FOWS & SCTAG comments on Draft EIS/R for proposed AM/SV Base to Base Gondola

The comment implies that the Draft EIS/EIR should have included a visual simulation of Alternative 2 from within the private lands within the congressionally mapped GCW (or the Caldwell property) because Alternative 2 would "prevent the land from being considered for purchase by the public (USFS) and/or conservation easement." Views 5 through 8 include the Caldwell property, from which the potential visual effects of the project under each alternative were considered. Additional views from within the Caldwell property were therefore not required to be included in the Draft EIS/EIR to adequately assess the impacts of the project. Please refer to *North Coast Rivers Alliance v. Marin Municipal Water Dist.* (2013) 216 Cal. App. 4th 614, 627-28 for further information.

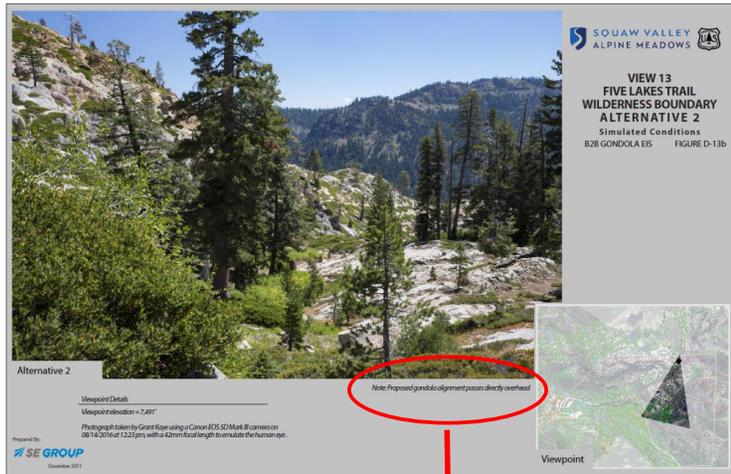
impact to this viewpoint by Alternative 2, however noted in a small font below the seemingly 'unaffected' viewpoint is the statement that the gondola would pass directly overhead. This raises questions about the appropriateness of this viewpoint. Further, the simulated view may mislead readers by failing to project the visual impacts of a gondola overhead.

View 13 remains appropriate for inclusion in this viewpoint analysis because of the useful perspective it provides for both Alternatives 3 and 4. While View 13 does not depict gondola infrastructure for Alternative 2, the note below the image discloses the issue identified by the commenter; as such, this issue does not warrant the creation of a new visual simulation.
